Mooney Mite Series M-13
Service Bulletin No. 14

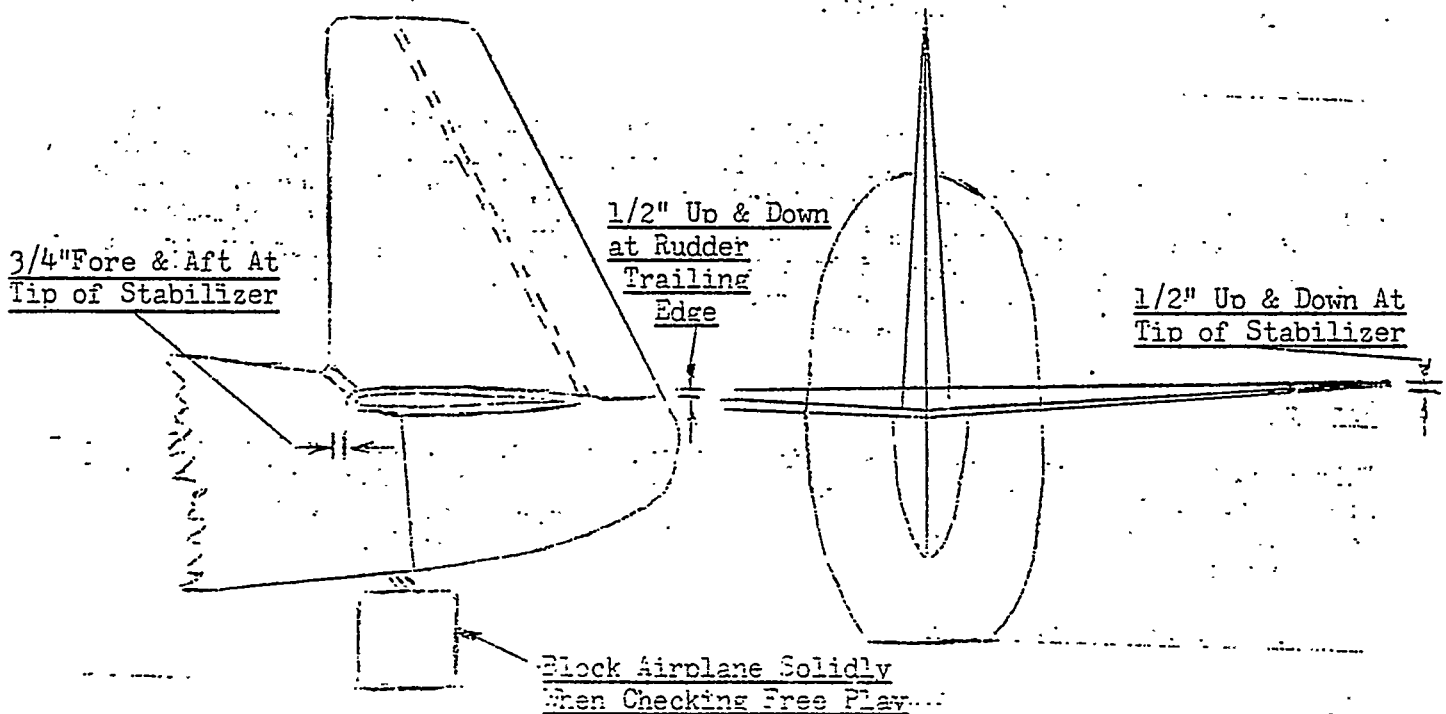
The following sketch illustrates the maximum allowable free play at the specified points.

When checking stabilizer tip free play, either fore and aft or up and down, measure free play on the opposite tip from where the stabilizer is moved by application of hand pressure. This eliminates errors in measuring due to bending deflections of the stabilizer itself.

First inspect all tail surface joints and attachment bolts for tightness. All Bolts Should Be Tight, since bushings are intended to take the wear. If any bolt is loose, inspect for wear, and replace if necessary, using washers if required, and make sure all bolts are tight. Then block tail of airplane solidly and check free play as indicated by sketch.

If any or all of free play limits are exceeded, find which joint or joints seem to have most play and replace bushings until free play is within limits. In this connection, the up and down free play at the rudder root trailing edge is also affected by wear in the adjustable stabilizer trim system, particularly for the Model M-18L, where the 886 screwjack, located at the rear fuselage bulkhead, may exhibit excessive end play. In this case, either replace or rework the screwjack to eliminate the excessive end play.
